**RE: Submission of Part One of Two Responses to CEEA Round One
Information Requirements and Required Clarifications for the Nexen
Energy ULC Flemish Pass Exploration Drilling Project : CEAR 80117**

NEXEN ENERGY ULC FLEMISH PASS EXPLORATION DRILLING (2018 – 2028)

Environmental Impact Statement Addendum Responses to Round One Information Requirements and Required Clarifications – Part One of Two

Figure IR-06.1 Simple Depiction of Main Wellbore and Sidetrack Wellbore

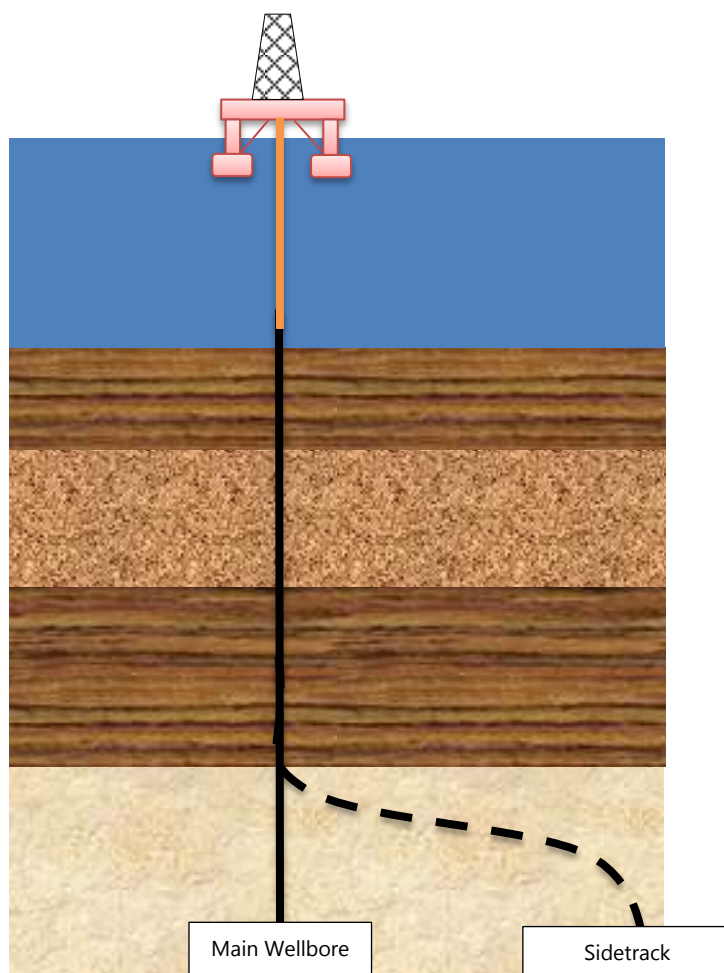
Specific Question or Information Requirement: Provide a description of project components and activities, including acid stimulation and sidetracking.

Sidetracking of the wellbore is an industry term for re-drilling a portion of the wellbore that has either been drilled to the planned total depth or partially drilled. This would involve permanently abandoning the section of wellbore below the start point from where the sidetrack well would be directionally drilled. Sidetracking might be done to either avoid an obstruction in the original wellbore or to reach another bottom hole location of geologic significance (i.e., geologic target). The impact on waste streams would be that a section of the wellbore would be drilled twice therefore generating additional drill cuttings that would be processed for discharge.

In the event of a sidetrack, the upper portions of the well would remain intact (i.e., no additional seabed penetrations, wellheads, or repositioning of the mobile offshore drilling unit (MODU)). Although sidetracking is currently not a planned activity, the additional time and associated waste streams have already been considered in the EIS (Section 2.9.2.3 and Appendix D).

The discussion above indicates that there are no plans to employ acid stimulation, and sidetracking is currently not a planned activity. However, both have been considered in the EIS, and the effects predictions presented in the EIS remain valid.

Figure IR-12.1 EIS Figure 5-42 Changes in Mean Monthly Water Temperature (1976-1995 to 1996-2015)

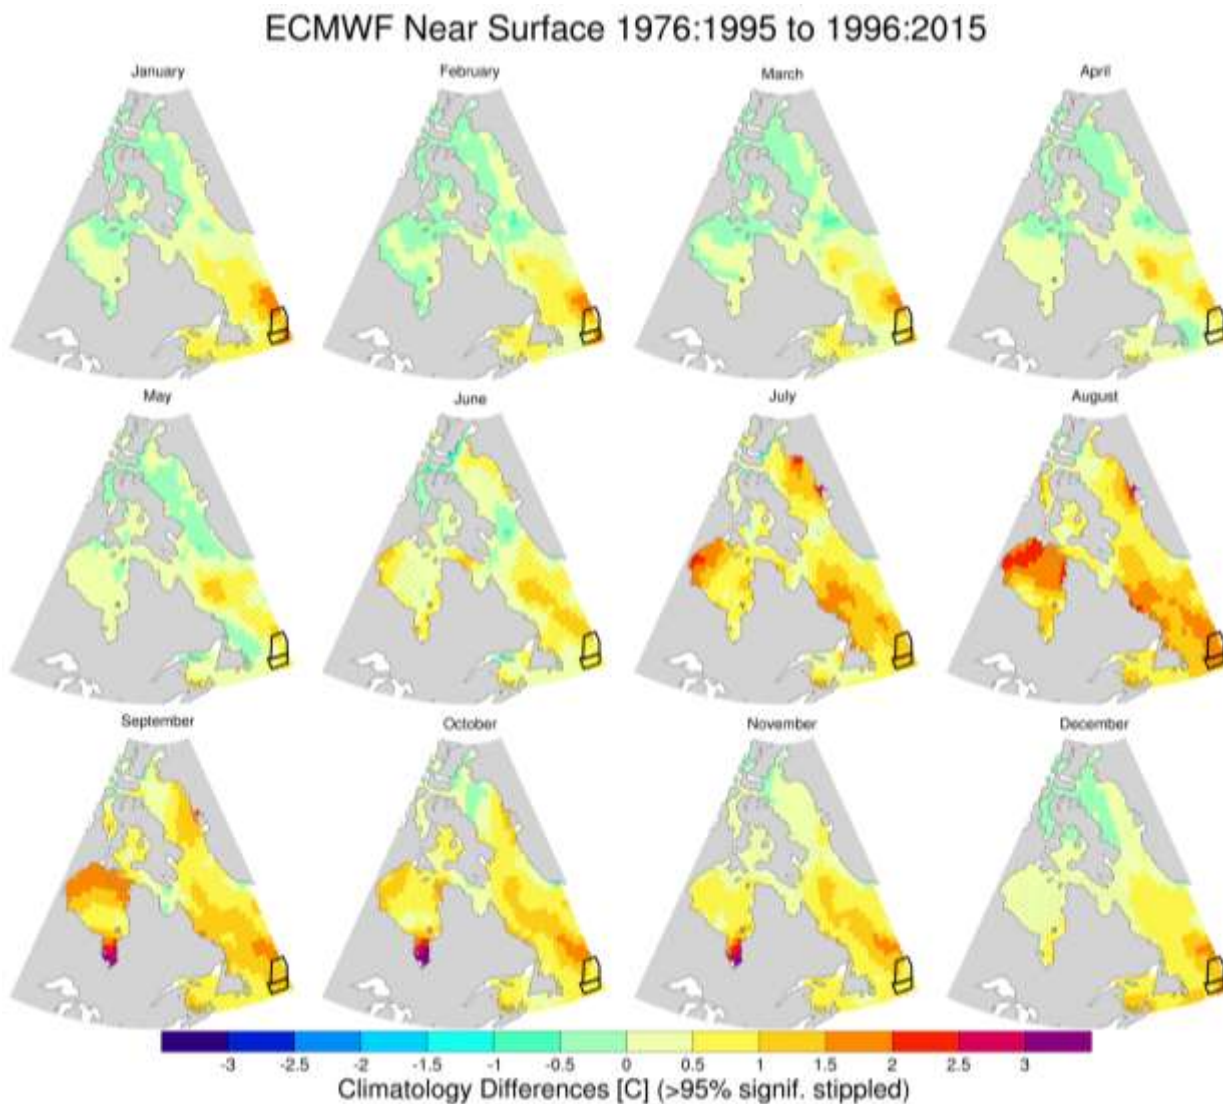
Part 3: Update the analysis of effects on Atlantic salmon, taking into consideration impacts that climate change may have had on the distribution of Atlantic salmon, and whether the Project could potentially contribute to or exacerbate an already declining population of salmon in the region.

As presented in Section 5.7.2.1 of the EIS, Figure 5-42 shows changes in mean monthly water temperature from 1976-1995 to 1996-2015 at depths of approximately five metres, based on European Centre for Medium-Range Weather Forecasts (ECMWF) reanalysis data. The Project Area has experienced warming in each month, although statistically significant warming is most prevalent from late summer to early winter. Warming was also found to be widespread at depths of approximately 45 m (not shown in Figure 5-42 of the EIS).

The limited interaction between salmon migrating within and near the Project Area and post-smolt and adults feeding north in the Labrador Sea and kelts along the southern edge of the Grand Bank will most likely remain low given the predicted increases in SSTs (i.e., lower suitability) near the Project Area. As the potential for environmental effects of planned Project activities and overall risk to Atlantic salmon is low, it is predicted that the Project will not contribute, nor exacerbate declines, to salmon populations.

The conclusion in the EIS, based on available data, remains valid: the Project is not likely to result in significant adverse environmental effects on marine fish and fish habitat, including Atlantic salmon.

Figure IR-22.1 Total Drill Cuttings Deposition, EL-1144 Deepwater Jurassic Example Well. Left) June, one Simulation (1 Jun); Right) "June", 46 Simulations (1 May-30Jul, every 2 days)

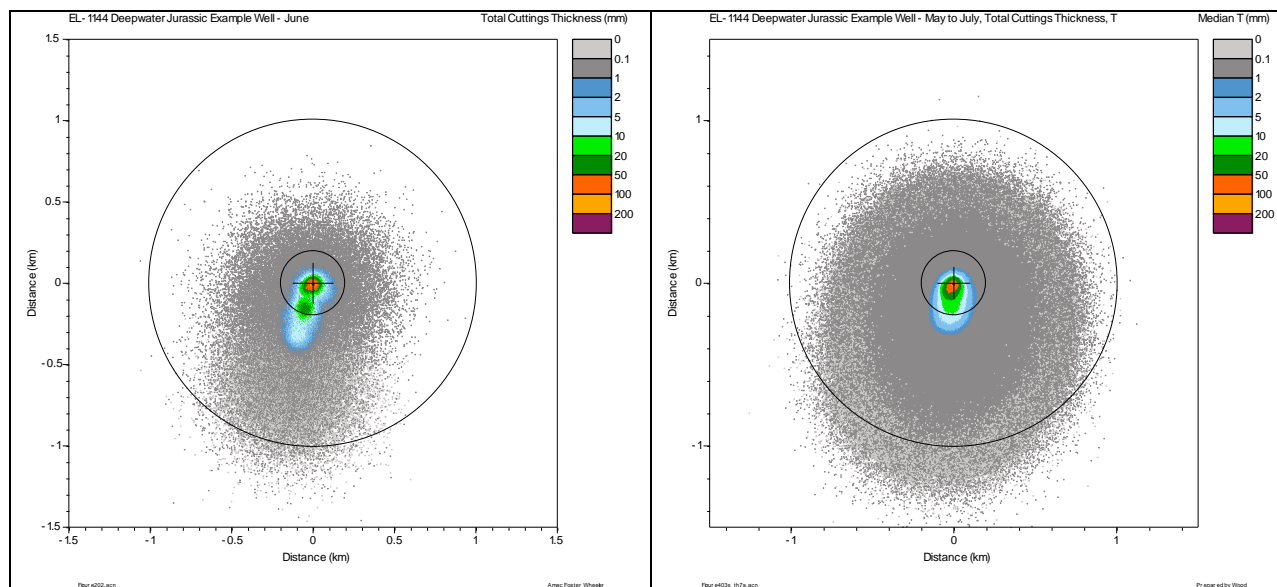
- a. Incorporate stochastic analysis in drill cutting dispersion scenarios, or provide a rationale for use of four simulations.
- b. Explain whether the dispersion model has considered processes at the benthic boundary layer (e.g. the presence of a mud plume/cloud near the bottom, and how this affects drill cutting dispersion predictions). If this is not addressed by the model, discuss the implications for model results.
- c. Provide a justification for the assumption that currents are uniform over the deposition grids modelled.
- d. Provide a rationale for the model selected and for the use of the turbulent diffusion term, and discuss the limitations of modelling without the use of advective-diffusive equations.

Part 2a - While stochastic analysis may help gain some statistical significance in the interpretation of output predictions, the four deterministic scenarios (at each location) completed do consider seasonal ocean current conditions which should provide a reasonable prediction of the possible direction and extent of the cuttings footprints which is the primary objective for the modelling. A comparison of an EL 1144 Deepwater Jurassic Example Well, June deterministic run commencing 1 June (Figure IR-22.1, left panel) with a stochastic simulation that considers 46 ensembles run every second day from 1 May to 30 July (i.e., 'covering' June) (Figure IR-22.1 right panel), is shown below. These are the total cuttings footprints. The stochastic run (Figure IR-22.1 right panel) footprint shows the median thickness. Both predictions show similar footprint extent and thickness.

Part 2b - The dispersion model does not consider processes at the benthic boundary layer. This could include resuspension of cuttings with the potential for sediment mobilization based on current speed, e.g., clays and fines, potentially mobilizing at lower current speeds, sands requiring higher speeds to move. Breakup of flocculates might be expected to reduce near-bottom concentrations, i.e., particles resuspend and are advected away by the ambient currents. Bioturbation is another process and difficult to quantify the intensity and rate of reworking that might take place at any of the locations. These post-depositional processes are difficult to model and data are scarce. The implications of not modelling these processes can result in over-prediction of benthic impacts (IOGP 2016) and so using the predicted no effect threshold (PNET) values as a guide to areas potentially affected is likely conservative. Conservative in the sense that subsequent resuspension and further transport would likely make the thicknesses smaller.
